Fermilab

TS-SSC 90-59

Subject: Evaluation of yoking tooling design

Figure 1a

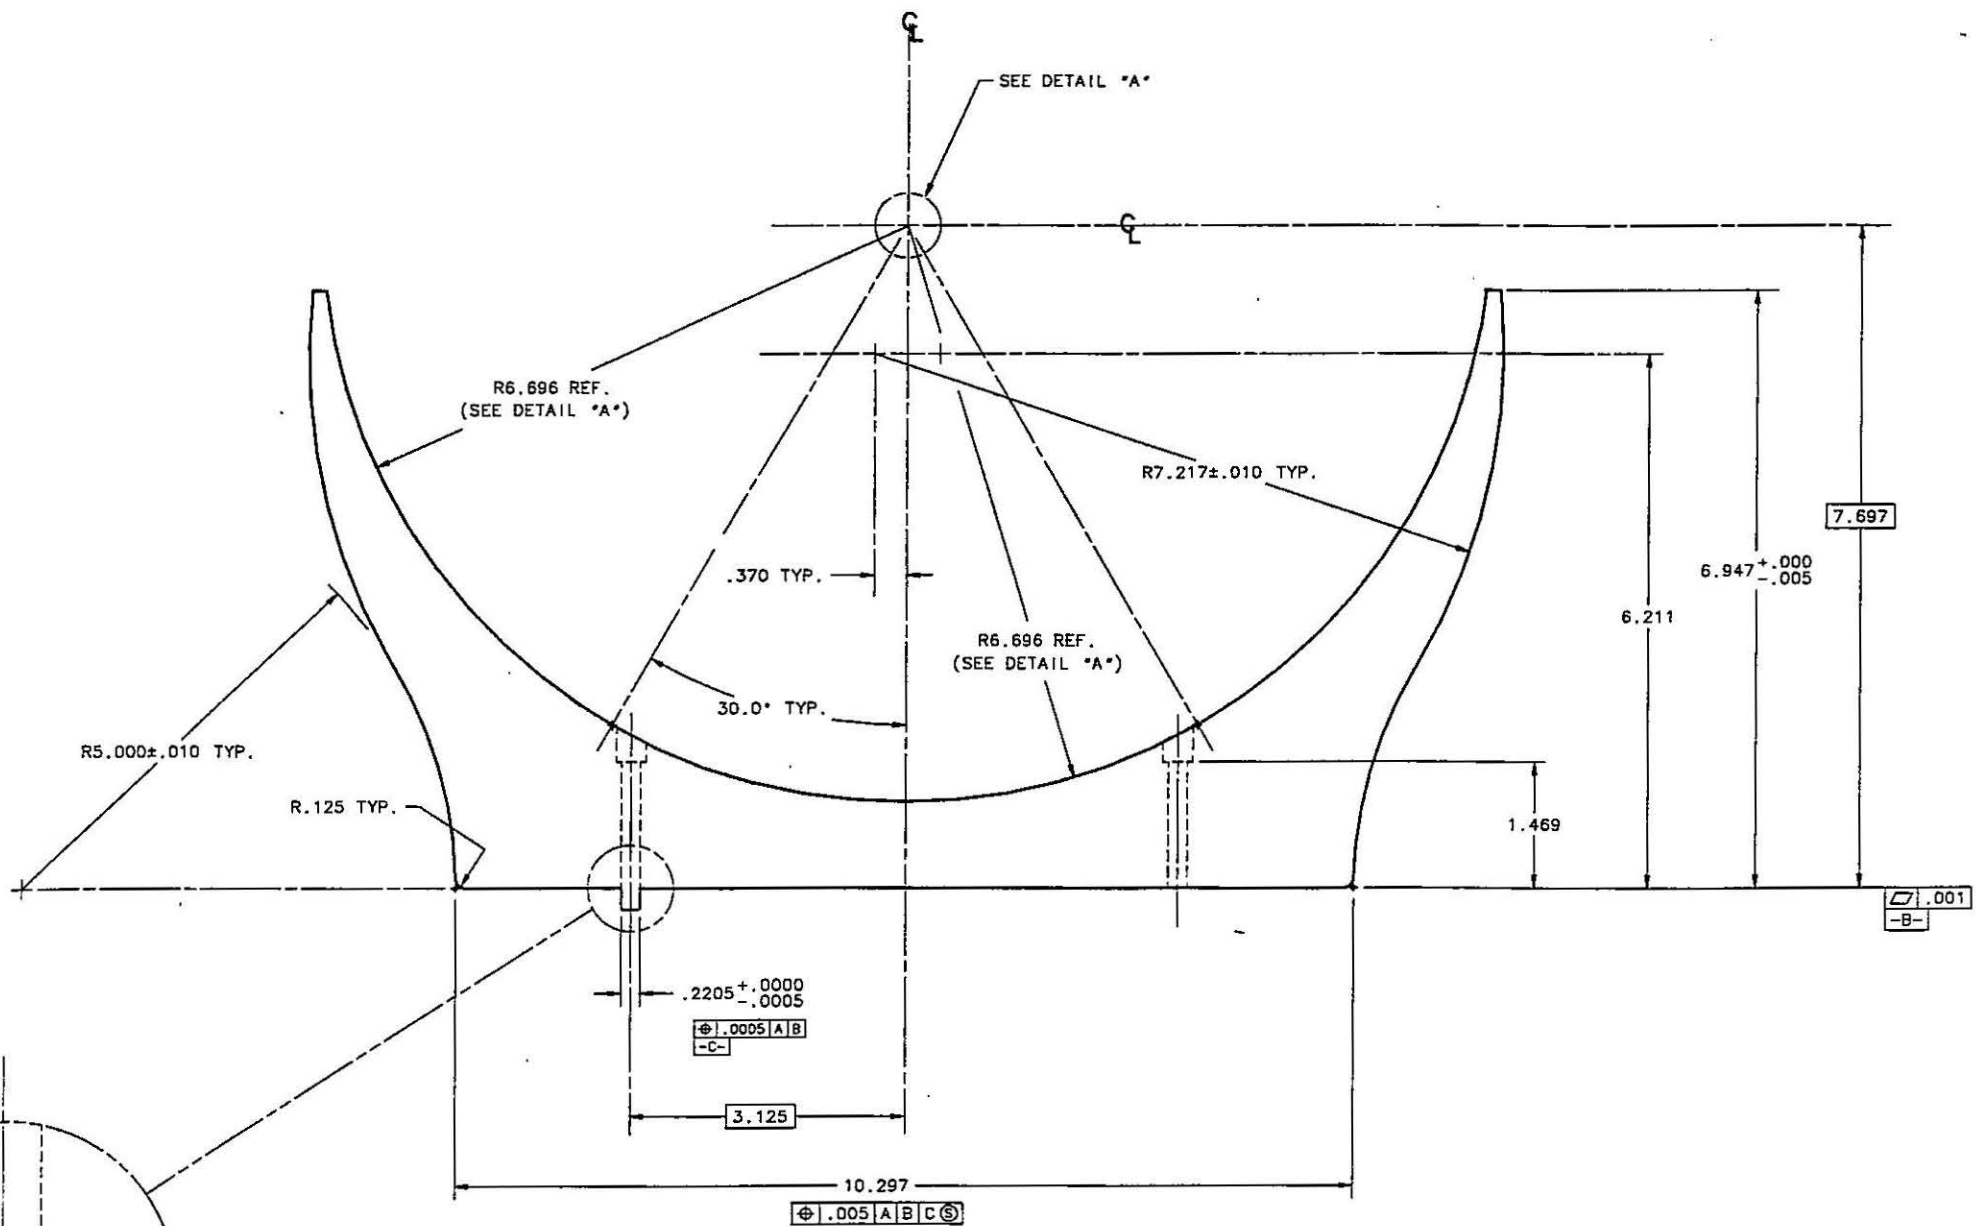
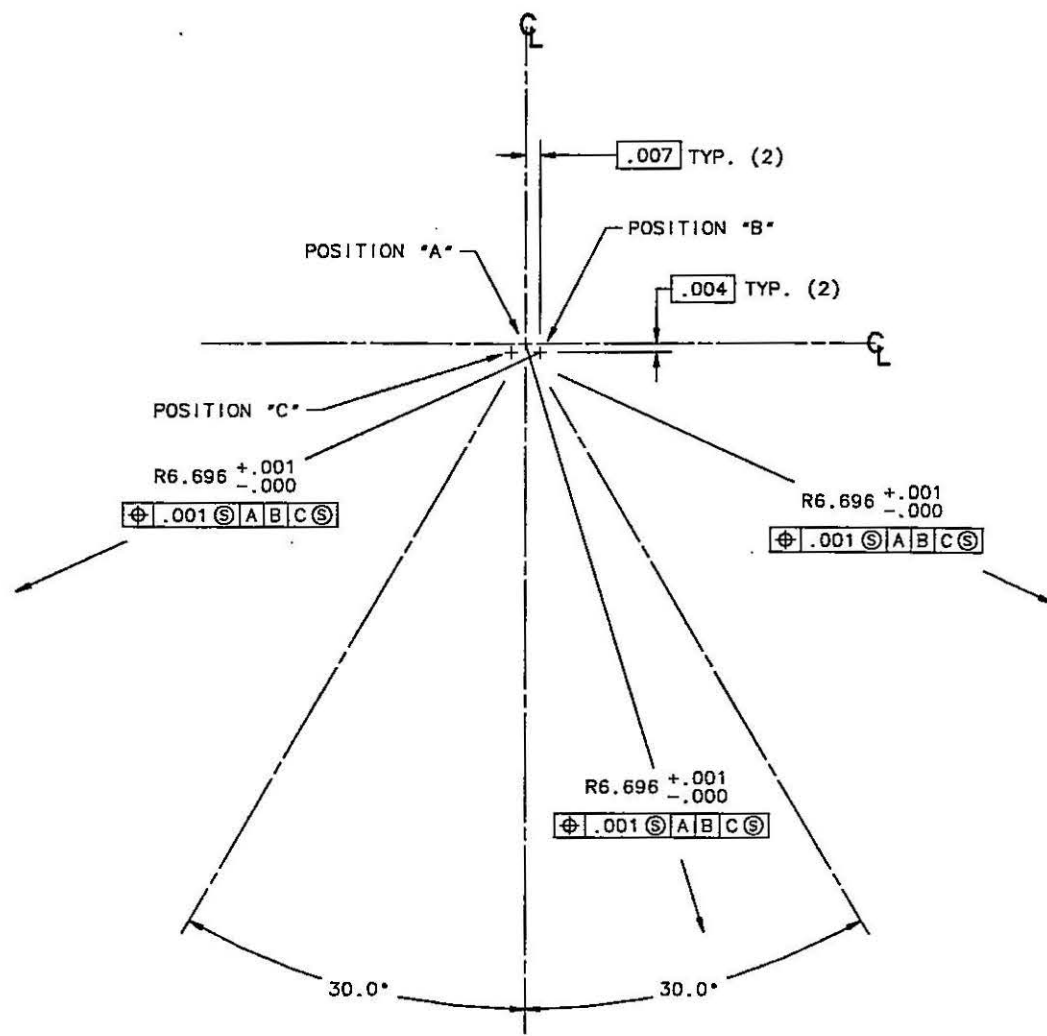
The yoking tooling insert is shown in Figure 1 (taken from drawing 0102-ME-293169). The inner surface has a nominal radius equal to the sum of the maximum yoke radius and maximum skin thickness allowed by their respective tolerances. The nominal tooling radius is the minimum allowed by its tolerance. The center of curvature is at two different locations for the regions 0 to 60 degrees and 60 to 90 degrees from the weld. The center in the former region is shifted 7 mils the the "left" and 4 mils "down" relative to the latter region. In the region far from the weld the tooling is very rigid, while closer the the weld the tooling consists of a tapered "finger" which serves to limit the radial pressure applied to the skin while ensuring that the skin conforms to the yoke before welding. Because of yoke-skin and skin-tooling friction, the skin azimuthal tension is reduced by the radial pressure of the tooling and therefore this pressure should be minimized[2].

The combined tolerance bands on the yoke radius ( $\pm 0.0005$  in.), the skin thickness ( $\pm 0.0025$  in.) and the tooling ( $+0.001/-0.000$  in.) corresponds to a range of 7 mils. The interference and clearance between the skin and tooling are plotted in Figures 2a and 2b for the maximum and minimum interference conditions. It is assumed that the yoke+skin and the tooling are tangent at the point 90 degrees from the weld. The skin radial pressures calculated by Eric are shown in Figures 3a and 3b for the maximum and minimum material conditions respectively. (Compressive stress is defined here to be negative.) For the minimum material condition, Eric provided me with runs with two different "spring rates" for the skin-tooling gap elements; both are plotted in Figure 3b. (I do not claim to understand what these spring rates are. I
